Subject: Request for Amendment to Technical  
Specification 3/4.3.2, "Isolation  
Actuation Instrumentation"

## DISCUSSION AND JUSTIFICATION FOR THE PROPOSED CHANGES

FIGURE 1.  
SIMPLIFIED FLOW DIAGRAM:  
RWCU SYSTEM

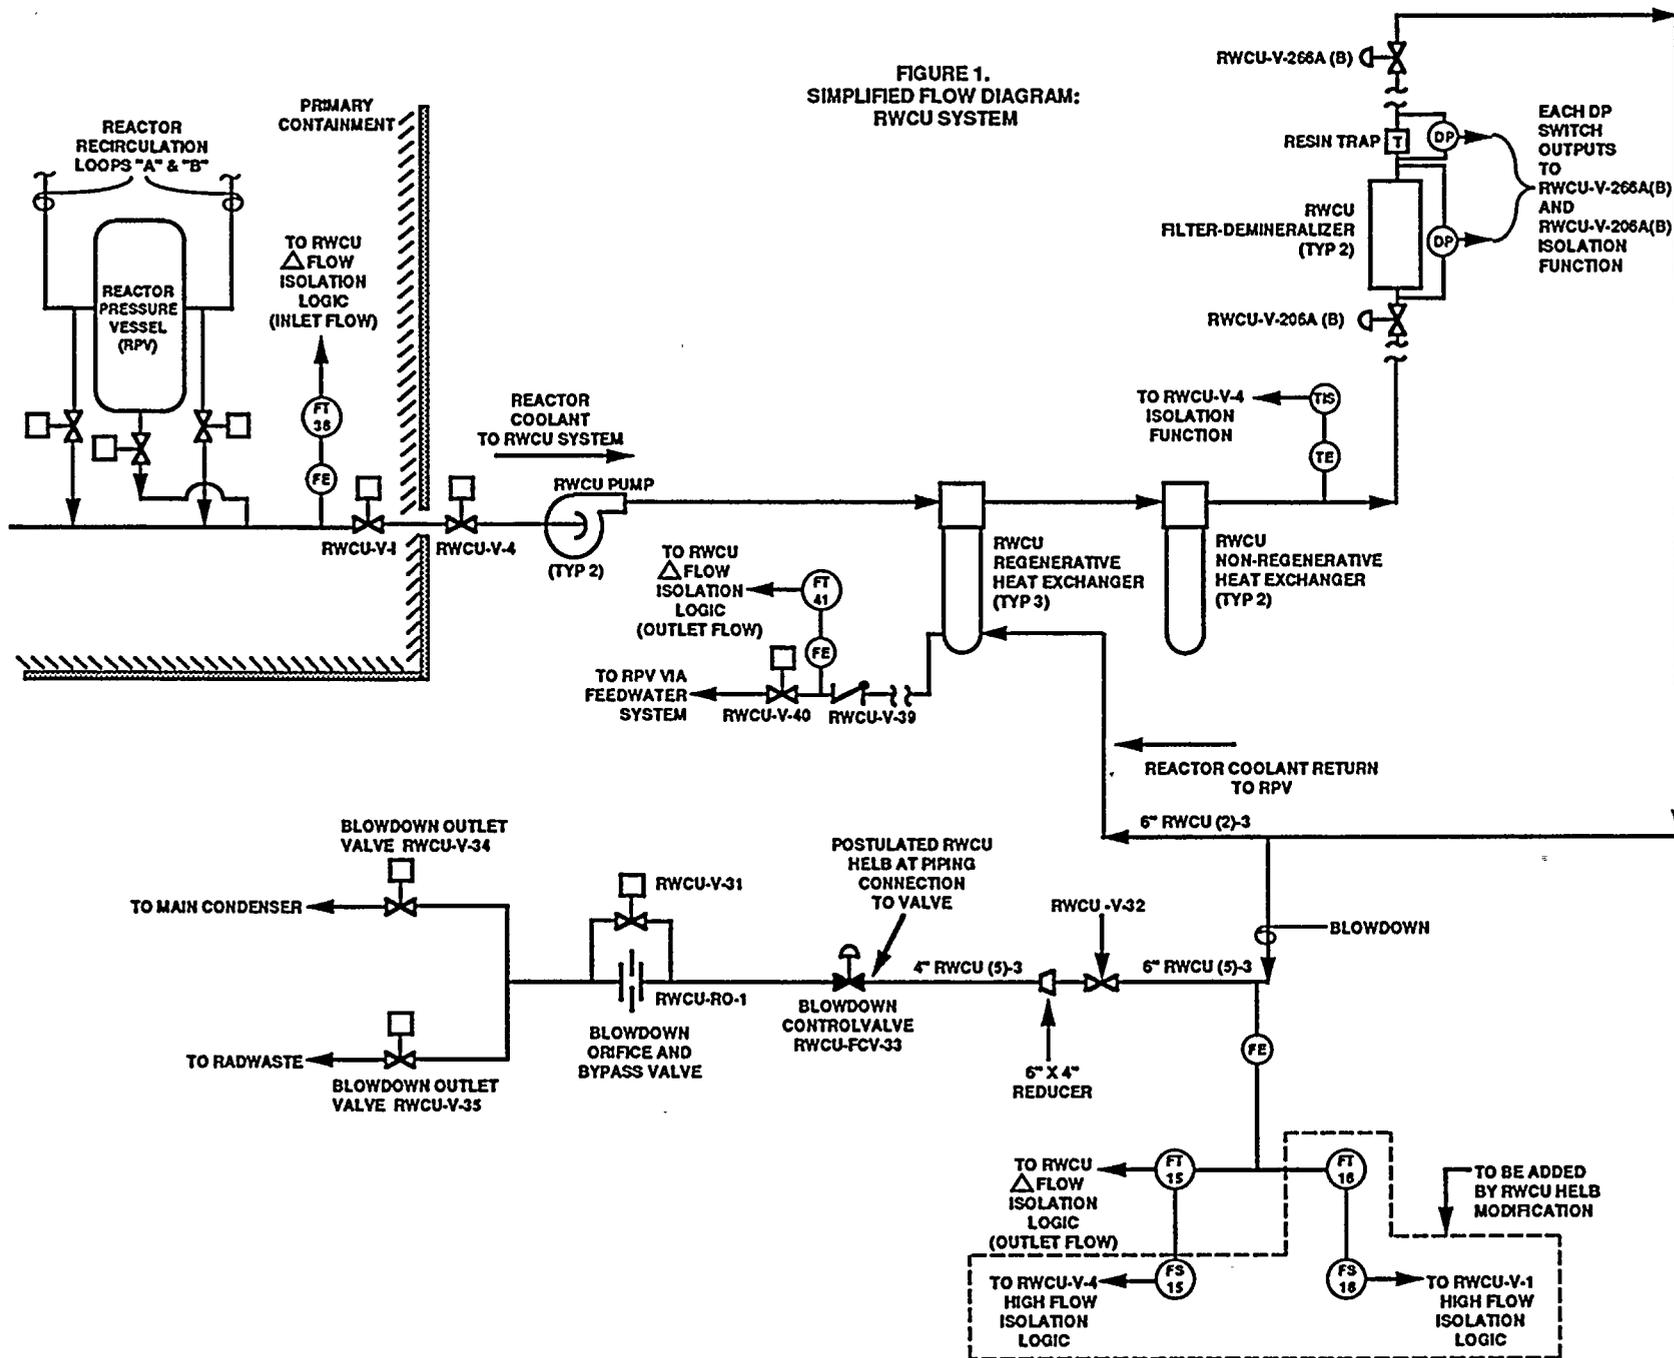
The RWCU system continuously purifies reactor coolant water during all modes of reactor operation and is described in WNP-2 Final Safety Analysis Report (FSAR), Subsection 5.4.8. Figure 1, "Simplified Flow Diagram: RWCU System," is enclosed for reference and information. The system takes suction from the inlet of each Reactor Recirculation (RRC) system pump and from the reactor pressure vessel (RPV) bottom head. Processed water is returned to the RPV via the Reactor Feedwater (RFW) system and/or the main condenser or the Radwaste system. The portion of the system located within the primary containment and the small portion located outside of containment up to and including the outboard containment isolation valve are considered part of the reactor coolant pressure boundary (RCPB). The other portions of the system are not part of the RCPB and, in the event of detected reactor coolant leakage, are automatically isolated by closure of an A.C. (inboard) and D.C. (outboard) motor-operated containment isolation valve (RWCU-V-1 and RWCU-V-4). The majority of the RWCU system equipment is located in the Reactor Building and include two RWCU pumps and three regenerative and two nonregenerative heat exchangers. The two filter-demineralizers and supporting equipment are located in the Radwaste Building.

A design change will be implemented prior to restart from the Spring 1995 (R-10) Maintenance and Refueling Outage to add a RWCU "Blowdown Flow - High" containment isolation trip function. The new trip function implements design features assumed in the analysis that generated the environmental profiles developed for the postulated RWCU HELB. This design change significantly improves the capability to detect and mitigate the effects of the HELB and is necessary to resolve Reactor Building environmental qualification concerns consistent with the new analysis. The design change adds two redundant Bailey Model 745 rack mounted electromechanical relay alarm units (flow switches) and a second redundant Rosemount Model 1153 flow transmitter. An additional square root extractor and flow indicator will also be provided to supplement existing flow indication instrumentation to allow operational channel checks. The design change further adds the two pipe whip restraints identified in the pipe whip analysis as being necessary to prevent damage to the flow transmitter lines used to detect the HELB. The new trip function design will reduce the HELB detection and isolation initiation time from 45 seconds to 2.5 seconds to ensure that the environmental effects of the HELB are bounded by analyses. This also provides assurance that the environmental qualification of equipment located in the Reactor Building is maintained.

The Supply System proposes to amend Technical Specification 3/4.3.2, "Isolation Actuation Instrumentation" to add the new RWCU "Blowdown Flow - High" trip function to Tables 3.3.2-1, 3.3.2-2, and 4.3.2.1-1. This proposed amendment incorporates the design features being implemented to reduce the detection and isolation time for the postulated RWCU HELB.
